Hi-Fi Products  
**Service Bulletin**

**Model:** MHC-1500, FH-B7CD, FH-B5CD

**No.137**

**Subject:** CD No Operation

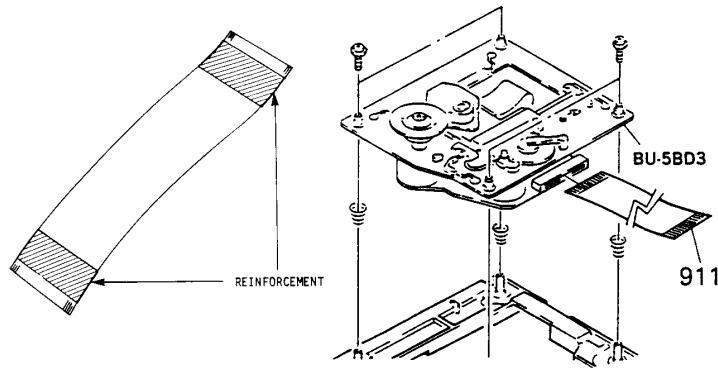
**Symptom:**  
(12)

If the CD is non-operational, it is caused by the flexible board with the terminal (between the BD Board and the Main Board) being disconnected.

**Solution:** Replace the flexible board with the new one which has been reinforced.

Ref. No.	Description	Part Number	
		Former	New
911	Flexible Board With Terminal	1-535-832-11	1-535-832-12
